Transforming and scaling up results and lessons learned in the Monte Alen and Rio Campo Landscapes through an inclusive Landscape-scale approach, effective land use planning and promotion of local governance

Review CEO Endorsement and Make a recommendation

10293

Equatorial Guinea

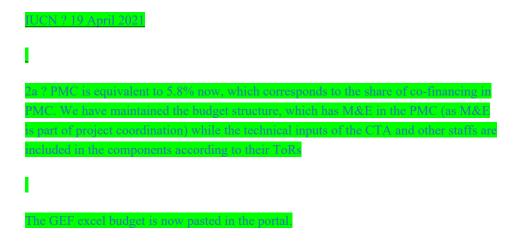
JS 3/22/2021 - The Results Framework has not been updated in the portal entry (Annex A), e.g. it still includes outputs 1.2.3 and 4.1.2, which no longer not exist according to the ProDoc, and the target METT scores are still the old ones. Please revise.

1-Please see comment above on missing METT scores and the low targets set for some METT score at project completion.
